Report of Change and Summary of 50.54(q) Analysis Emergency Plan Implementing Procedure 5.7.11, Revision 19

Emergency Plan Implementing Procedure 5.7.11, Revision 19

COOPER NUCLEAR STATION

EARLY DISMISSAL/EVACUATION OF SITE PERSONNEL

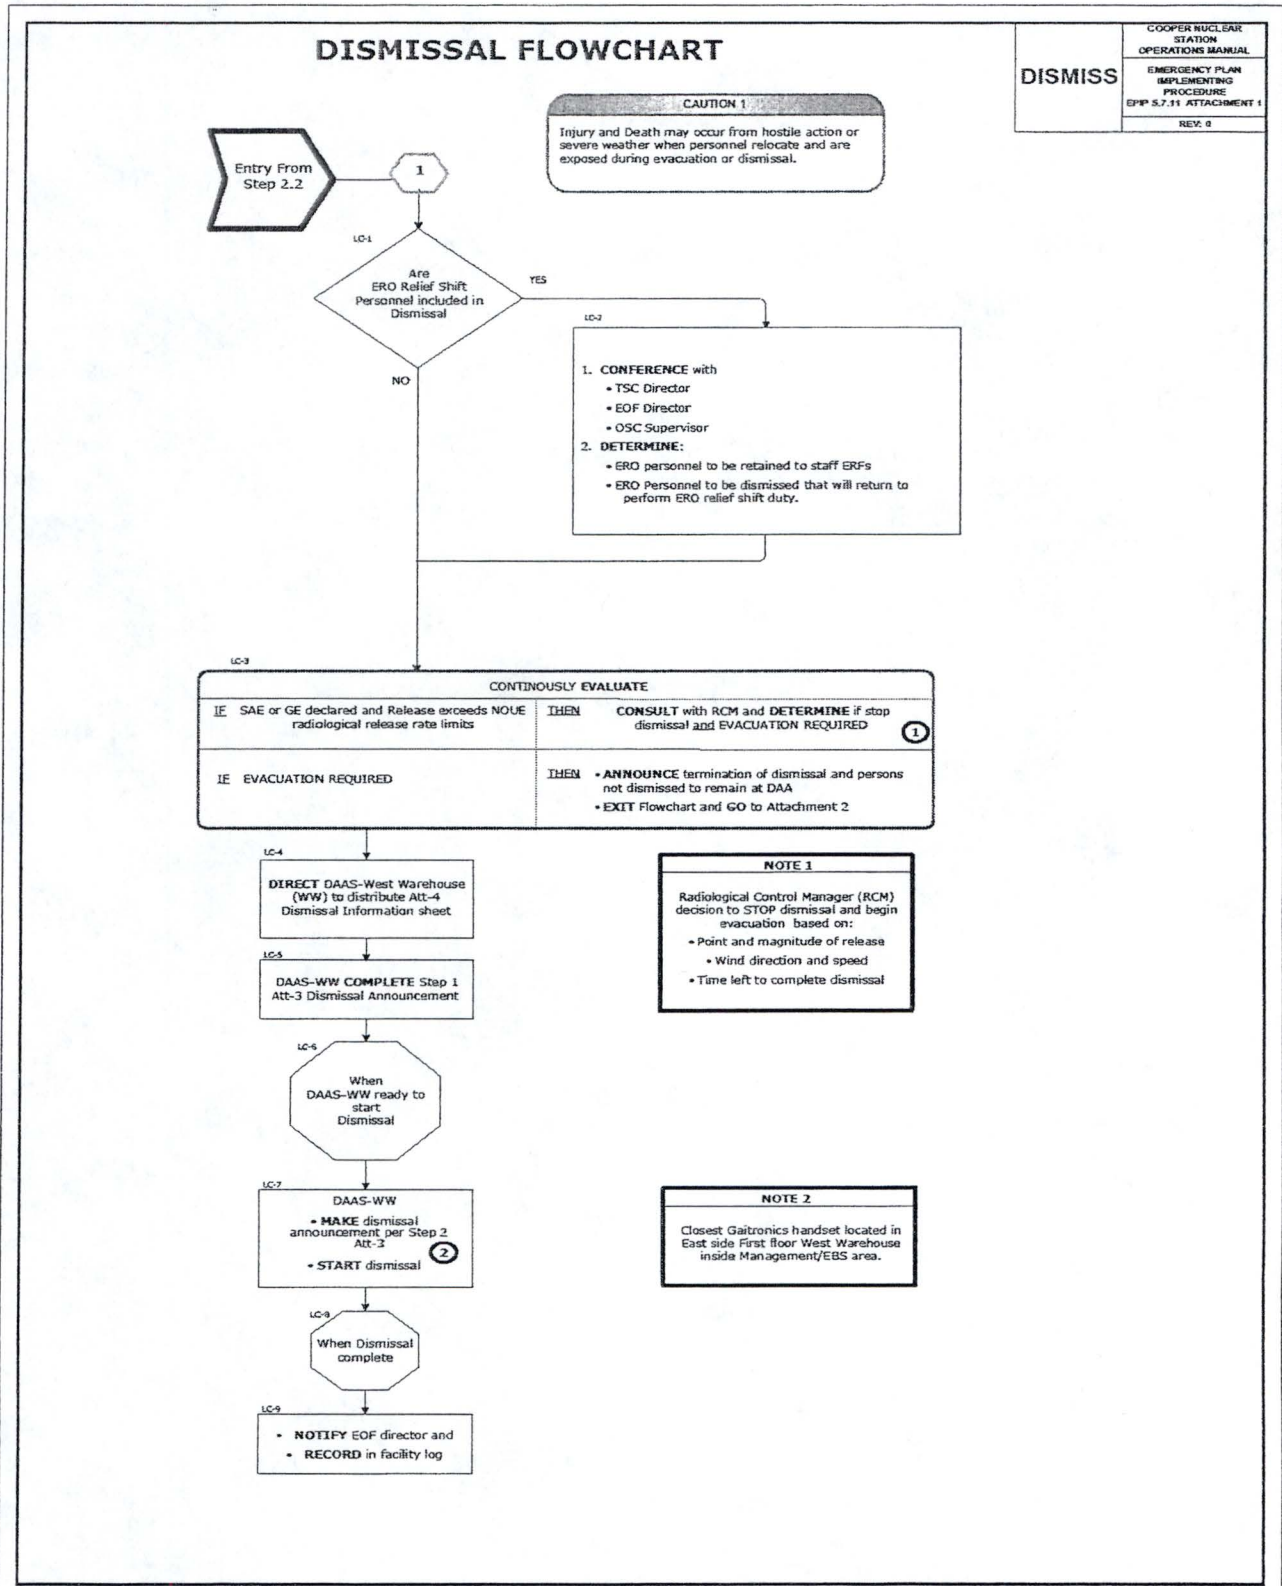
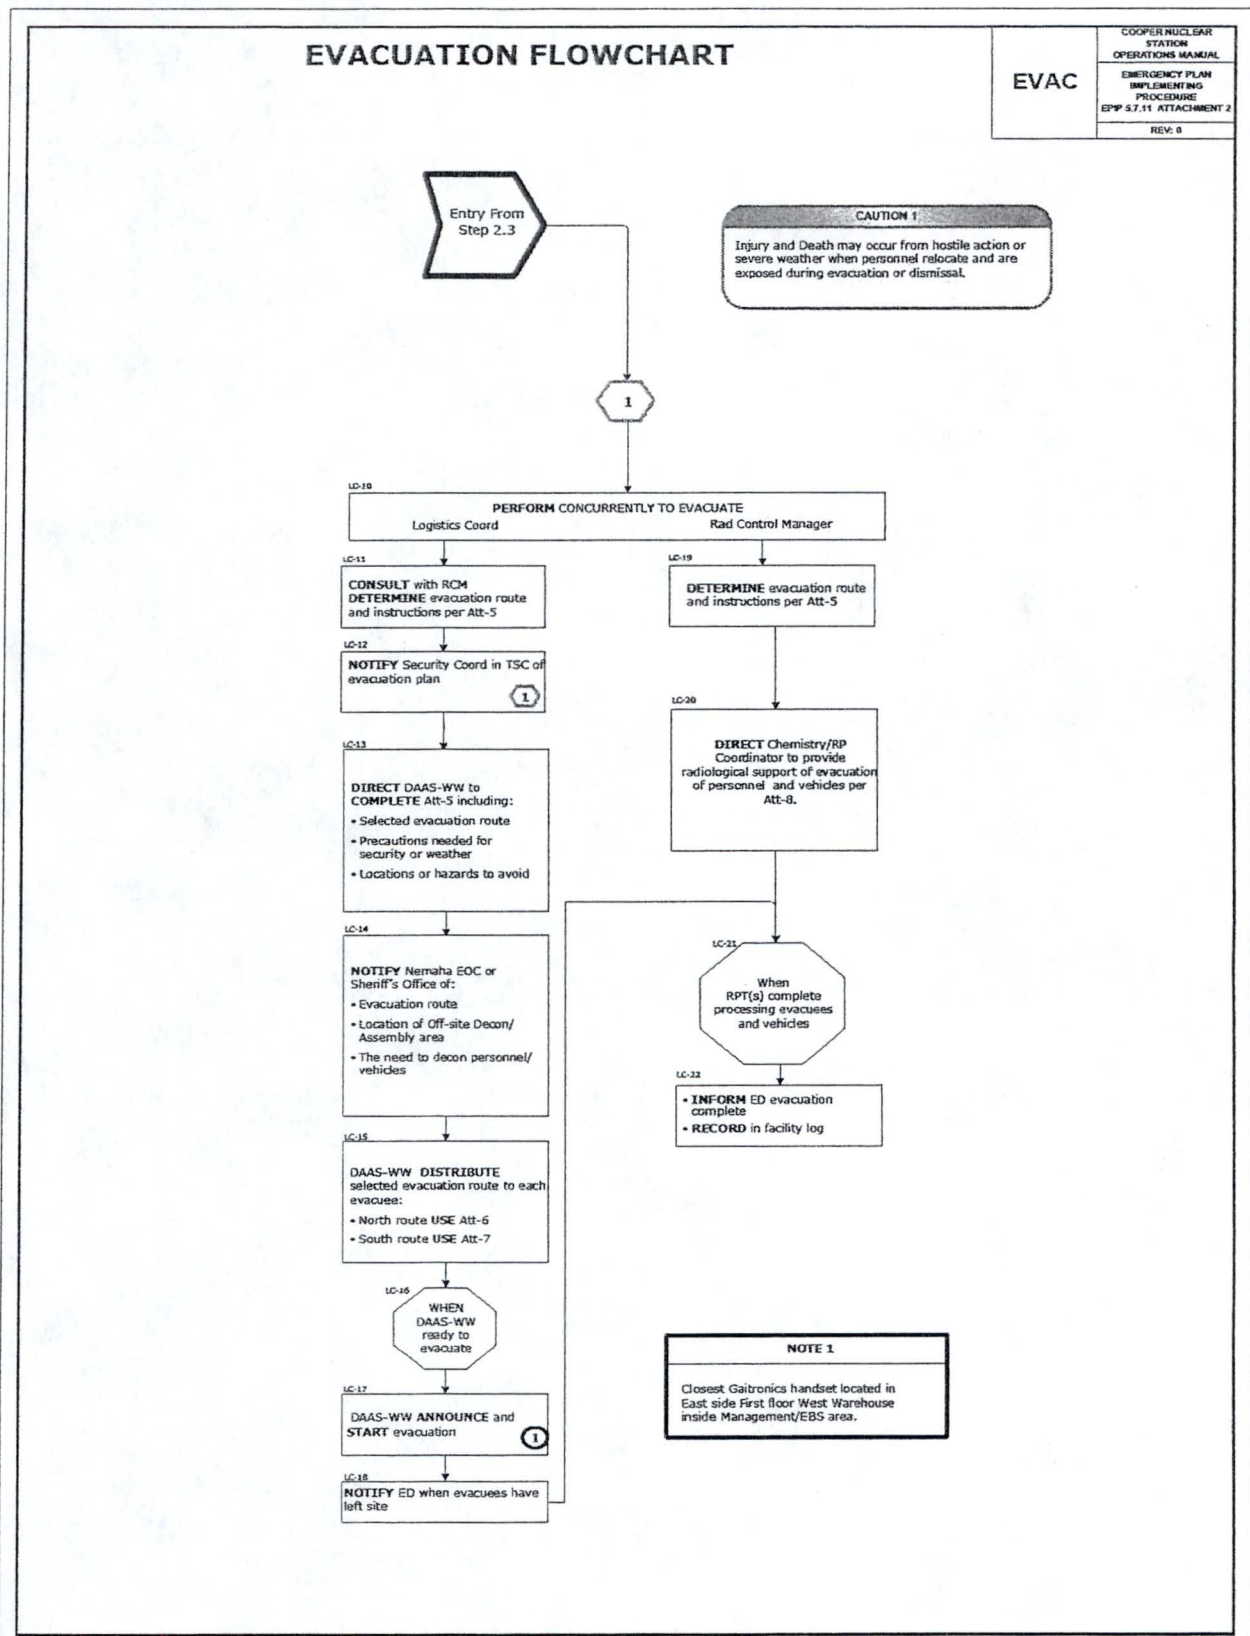
- Established Logistics Coordinator as lead in executing dismissal/evacuation.
- Clarified Radiological Control Manager as having the responsibility of decision maker for when to terminate dismissal and begin evacuation, and for determination of evacuation routes.
- Added new Attachments 1 and 2, (Dismissal Flowchart and Evacuation Flowchart), and transferred instructions for dismissal/evacuation actions into a flowchart format. Also added a Caution to these attachments concerning the potential threat of exposing personnel to severe weather or hostile action during dismissal or evacuation.
- Added a new Section 3.10 to provide administrative controls for the new Dismissal and Evacuation Flowchart hard cards.
